2018/12/07

MCRJ(-S)-Ø6~Ø8 Order Example Changed Notice

MCRJ(-S)-Ø6~Ø8

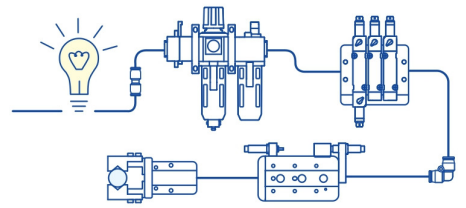
MCRJ(-S)-Ø6~Ø8 Order example updates according to the new product specification.

Before	After
<p>Old version catalog</p> <p>Order example</p> <p>MCRJ - 6 - 90</p> <div style="display: flex; justify-content: space-around; align-items: center;"> <div style="text-align: center;"> <p>MODEL</p>  </div> <div style="text-align: center;"> <p>TUBE I.D.</p>  </div> <div style="text-align: center;"> <p>ROTARY ANGLE</p> <p>90° 180°</p> </div> <div style="text-align: center;">  </div> </div>	<p>2018/12 catalog update</p> <p>Order example</p> <p>MCRJ - S - 6 - 90 - E</p> <div style="display: flex; justify-content: space-around; align-items: center;"> <div style="text-align: center;"> <p>MODEL</p>  </div> <div style="text-align: center;"> <p>STOPPER</p> <p>Blank: Standard type S: with external stopper</p> </div> <div style="text-align: center;"> <p>TUBE I.D.</p>  </div> <div style="text-align: center;"> <p>ROTARY ANGLE</p> <p>90° 180°</p> </div> <div style="border: 2px solid red; padding: 5px;"> <p>PORT LOCATION</p> <p>Blank: Side ported</p>  <p>E: Front ported</p>  </div> </div>

<p>2018/11/16 catalog update</p> <p>Order example</p> <p>MCRJ - S - 6 - 90 - E</p> <div style="display: flex; justify-content: space-around; align-items: center;"> <div style="text-align: center;"> <p>MODEL</p>  </div> <div style="text-align: center;"> <p>STOPPER</p> <p>Blank: Standard type S: with external stopper</p> </div> <div style="text-align: center;"> <p>TUBE I.D.</p>  </div> <div style="text-align: center;"> <p>ROTARY ANGLE</p> <p>90° 180°</p> </div> <div style="border: 2px solid red; padding: 5px;"> <p>PORT LOCATION</p> <p>Blank: Front ported</p>  <p>E: Side ported</p>  </div> </div> <div style="text-align: center; margin-top: 10px;">  </div>

*2018/11/16 catalog update→MCRJ Series new options for stopper 1.Standard type 2.with external stopper

*2018/12 catalog update→Port location code change

The change is effective from December 2018.
